To: T10 Technical Committee
From: Rob Elliott, HP (elliott@hp.com)
Date: 8 November 2003
Subject: 03-347r1 SES-2 Reporting peer enclosure service processes

Revision 0 (15 October 2003) First revision
Revision 1 (8 November 2003) Incorporated comments from November CAP WG - moved relative field left one bit.

Figure 2 — Multiple enclosure service processes

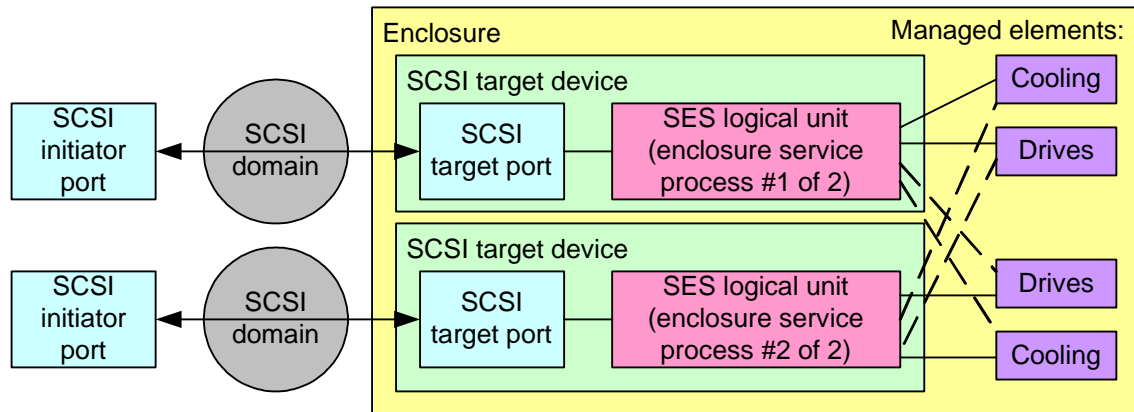
Figure 2 shows multiple enclosure service processes. Both return the same enclosure serial number, etc. in the Configuration diagnostic page. They might each have the ability to manage the full enclosure or just part of it (this can be determined by examining which elements they manage).

Bob Snively (Brocade) asked that a way be added to identify these situations to software. New fields are proposed for the Configuration diagnostic page that return the total number of enclosure service processes and a relative identifier (1 .. n) indicating which one is being accessed. Applications accessing the same enclosure from different domains can use this information to understand what the others are seeing.

The NUMBER OF ENCLOSURE SERVICE PROCESSES field indicates the number of enclosure service processes supported by the enclosure. A value of 0h means the number is not known.

The RELATIVE ENCLOSURE SERVICE PROCESS IDENTIFIER field identifies the enclosure service process relative to other enclosure service processes in the enclosure. A value of 0h is reserved.
